# NEBRASKA CAPITOL ENVIRONS COMMISSION

## AGENDA

## NEBRASKA CAPITOL ENVIRONS COMMISSION STAFF REPORT

## NEBRASKA CAPITOL ENVIRONS COMMISSION STAFF REPORT

## ATTACHMENT B – Site Plan

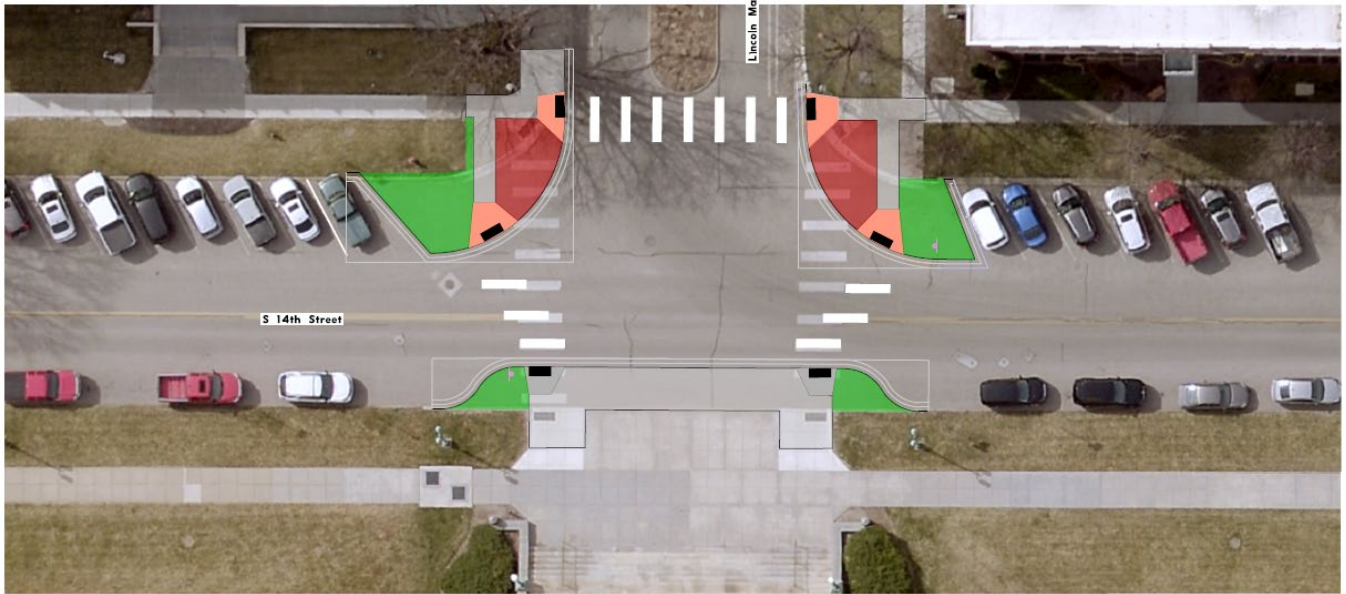
**Compatibility per Staff Analysis:** The standards emphasize the need for rhythm along the malls and a high standard of design facing Capitol Square, and the proposal appears to achieve that. LTU has incorporated pavers fields and colored concrete ramps in order to match the visual aesthetic of Lincoln Mall. Additionally, all material selections appear to be high-quality and maintenance-friendly as suggested by Guideline 18.5.

Staff believes that this proposal generally meets the intent of the standards. That said, staff does have some reservations about bumping out the east side of S 14<sup>th</sup> Street. Capitol Square does not currently have any bumpouts along its perimeter, and this proposal would obviously change that. LTU should listen to key stakeholders from the State – including both staff and senators – before finalizing plans to modify the Capitol Square curblines. If bumpouts were limited to just the west side of S 14<sup>th</sup>, pedestrian access and safety would still be significantly improved without causing disruption to Capitol operations.

**Recommended action:** Approval of a Certificate of Appropriateness for the proposed intersection improvements at S 14<sup>th</sup> Street and Lincoln Mall, with careful consideration of improvements on the east side of 14<sup>th</sup> Street to maintain consistency of and preserve the design of Capitol grounds.

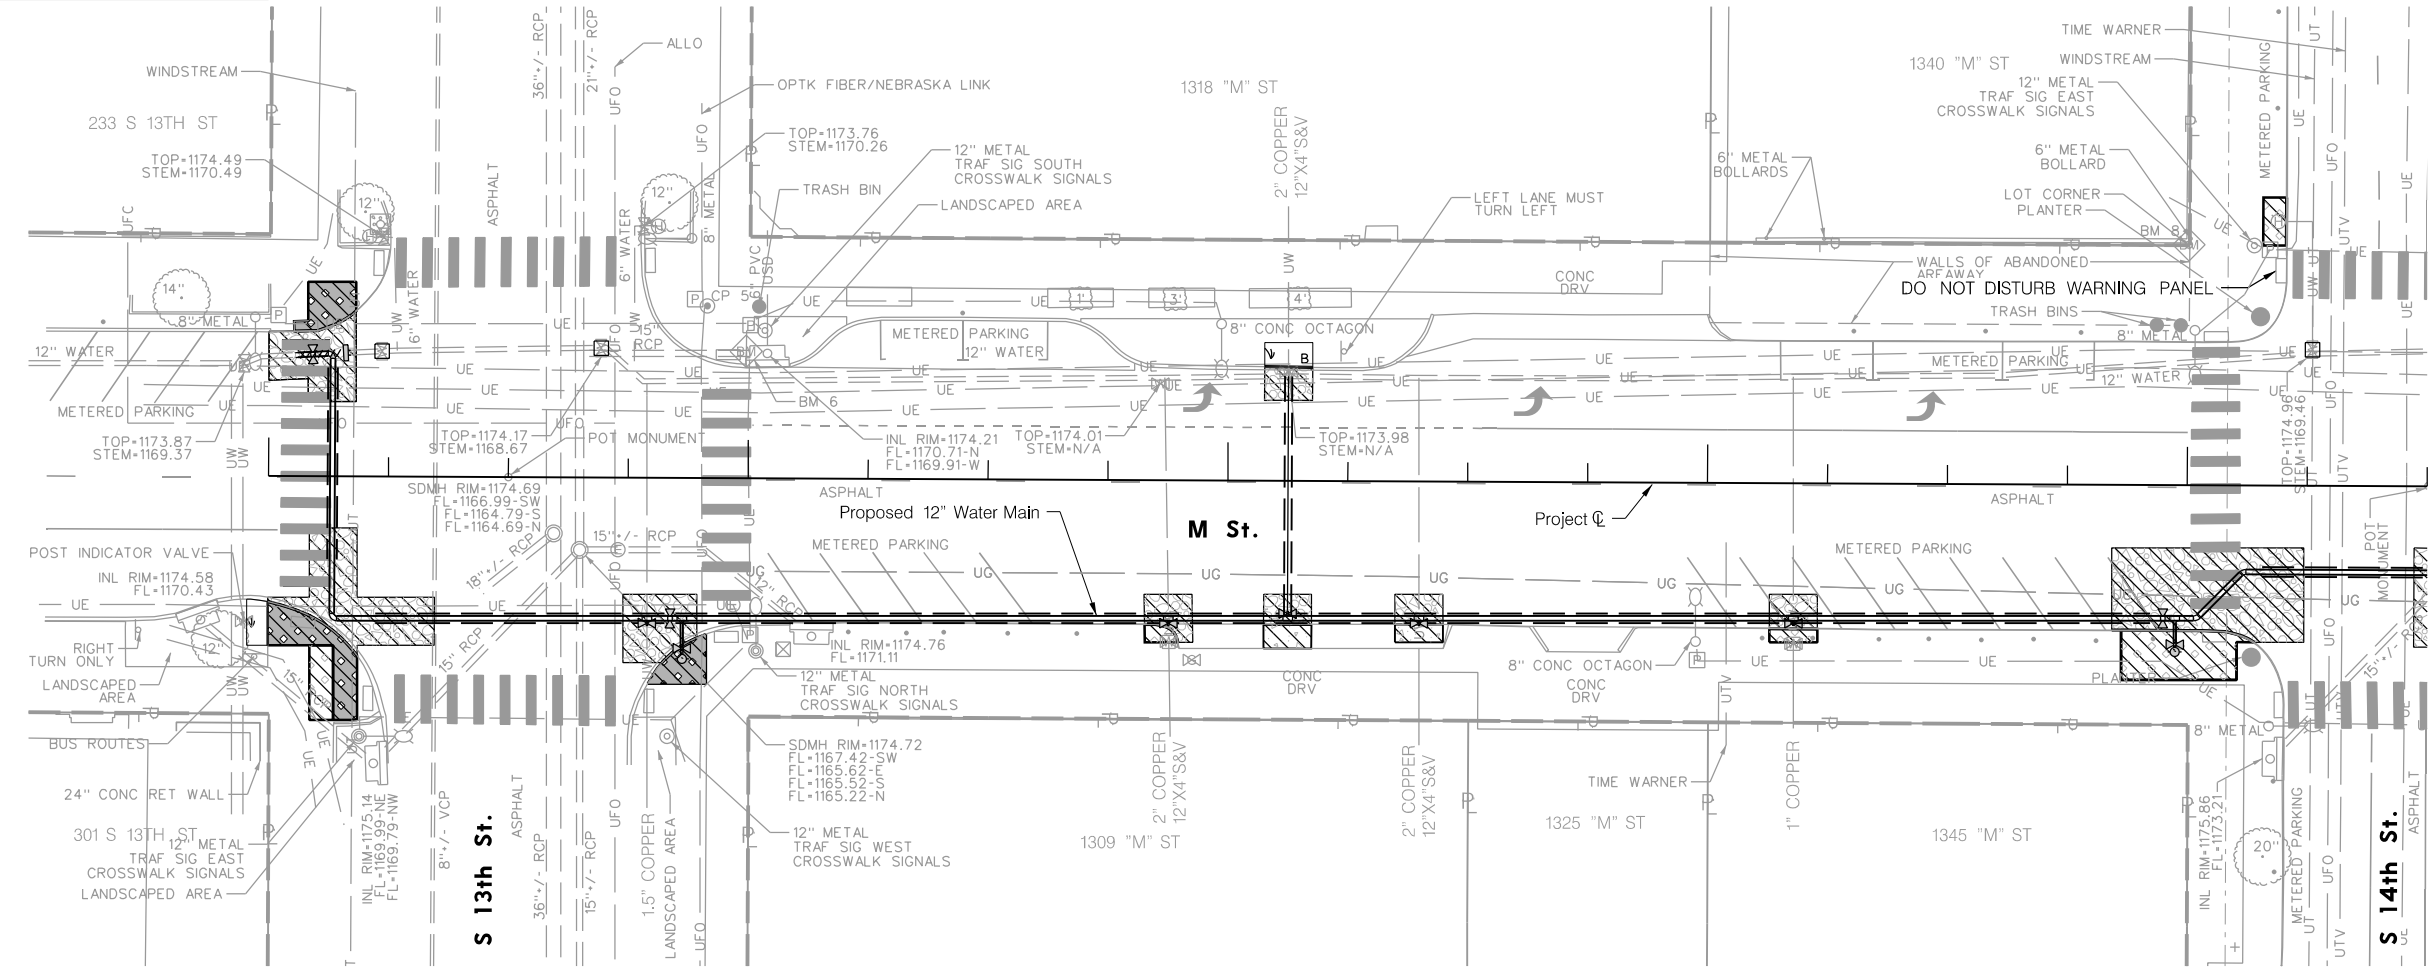
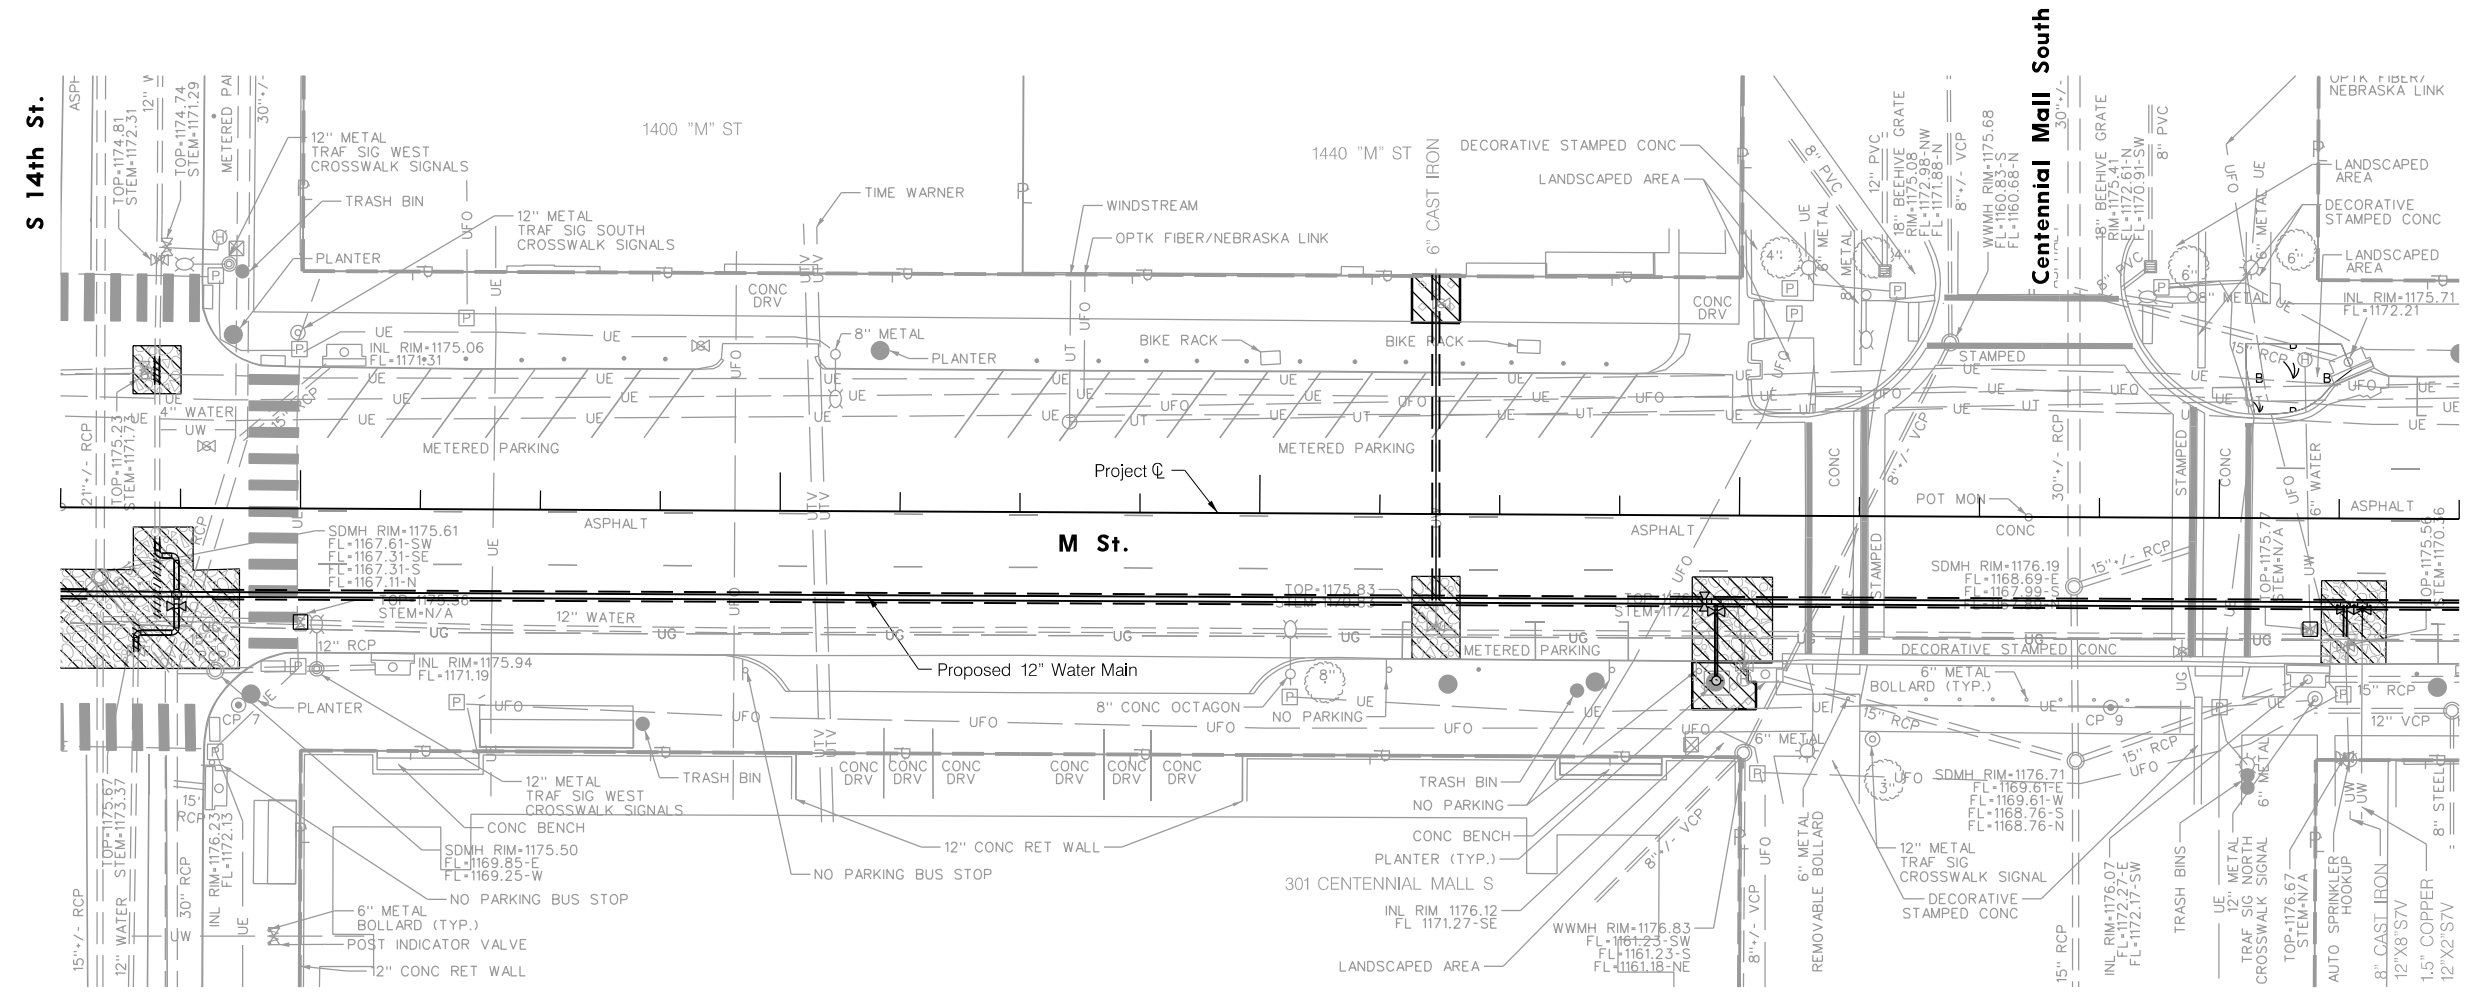
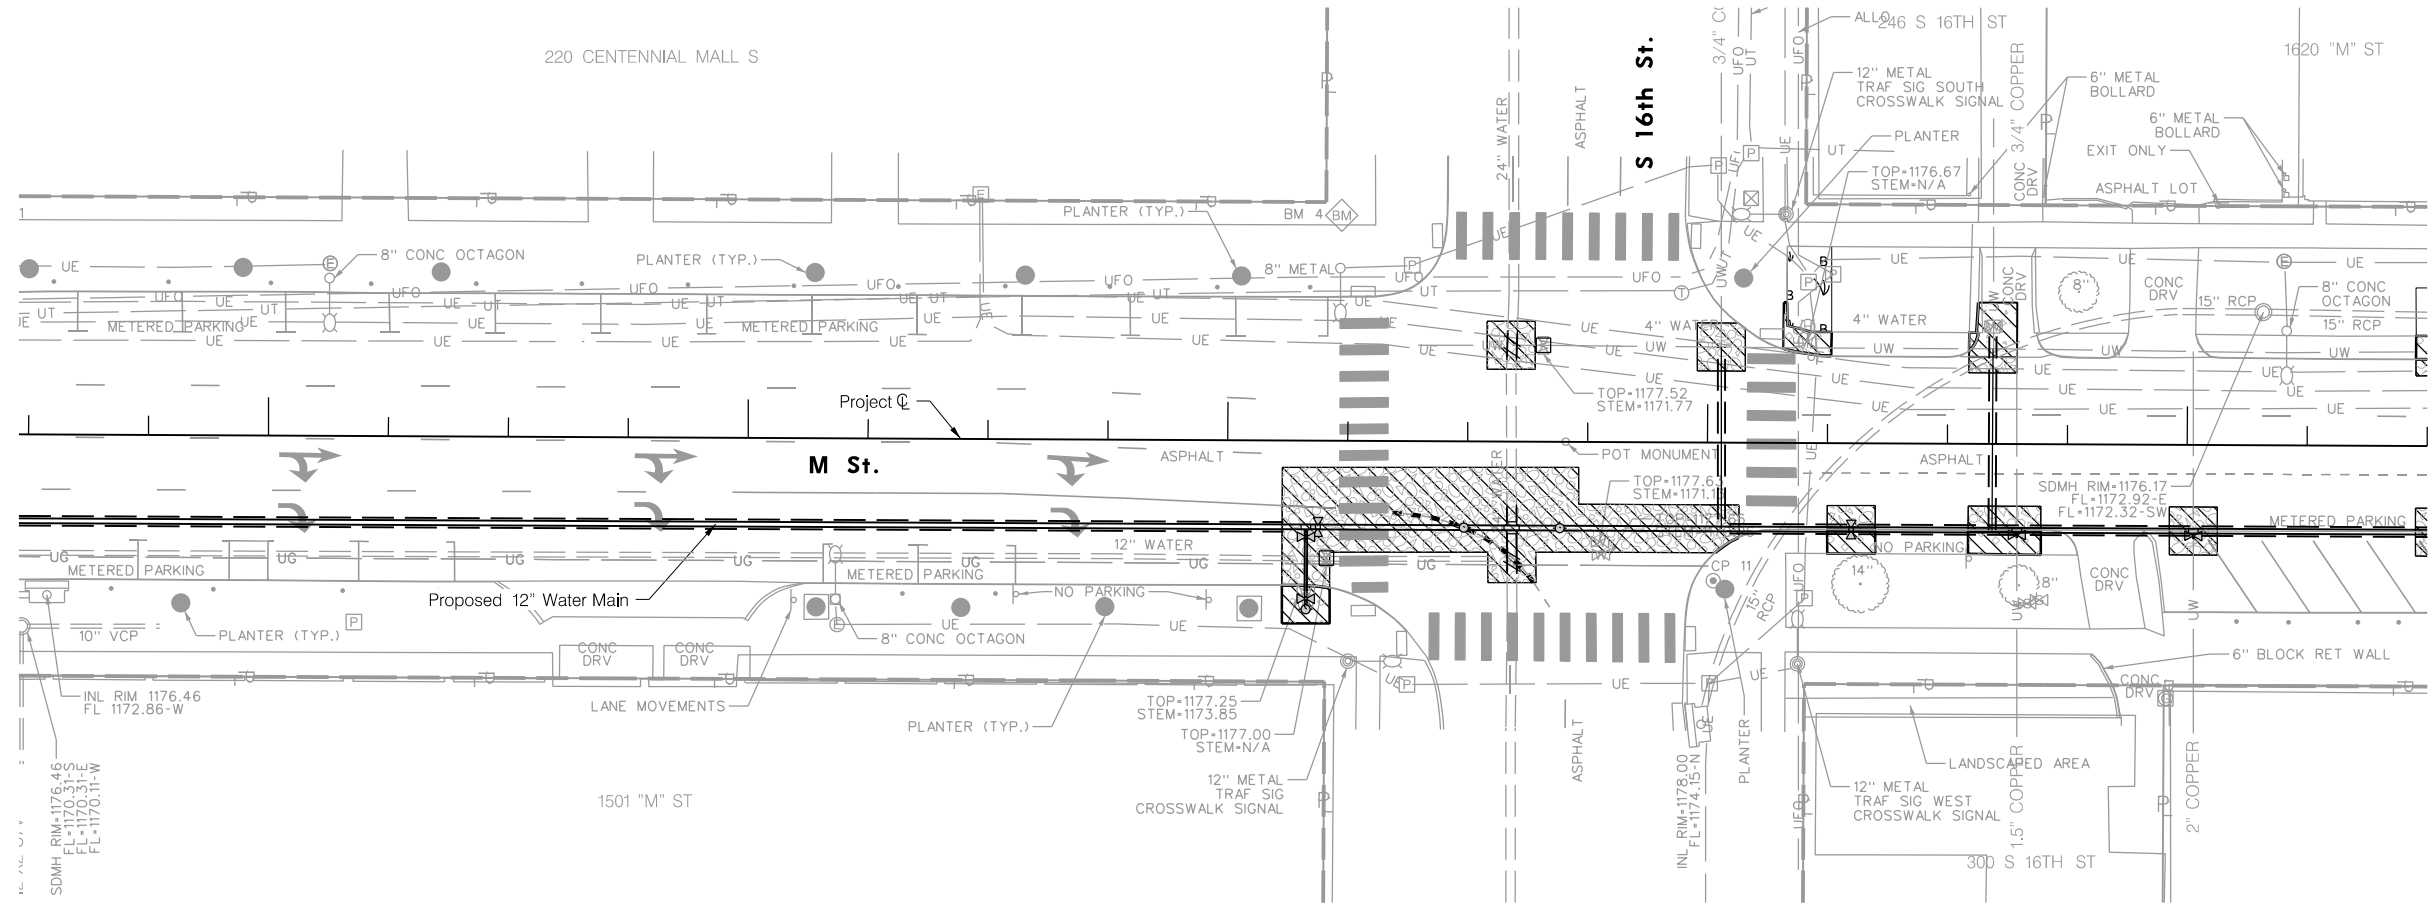
Lincoln Transportation and Utilities (LTU) is planning a water main replacement project for the south side of M Street from S 13<sup>th</sup> Street to Antelope Valley Parkway. This project intersects the Capitol Environs District from S 14<sup>th</sup> to S 16<sup>th</sup> streets. In reviewing the plans for the project, staff is of the opinion that the project will not have any long-term impacts on the Environs District. No trees are being removed, and the method for replacing the water main will result in limited impacts to the landscapes and hardscapes.

Given the nature of this project – an underground utility project resulting in minor impacts on the above-ground streetscape – there is not much in the standards that would apply. Ultimately, the key consideration will be LTU’s ability and commitment to properly restoring any landscape or hardscape elements disturbed in the construction process, returning the above-ground project area to its original state.

**Recommended action:** Approval of a Certificate of Appropriateness for the M Street water main replacement project.
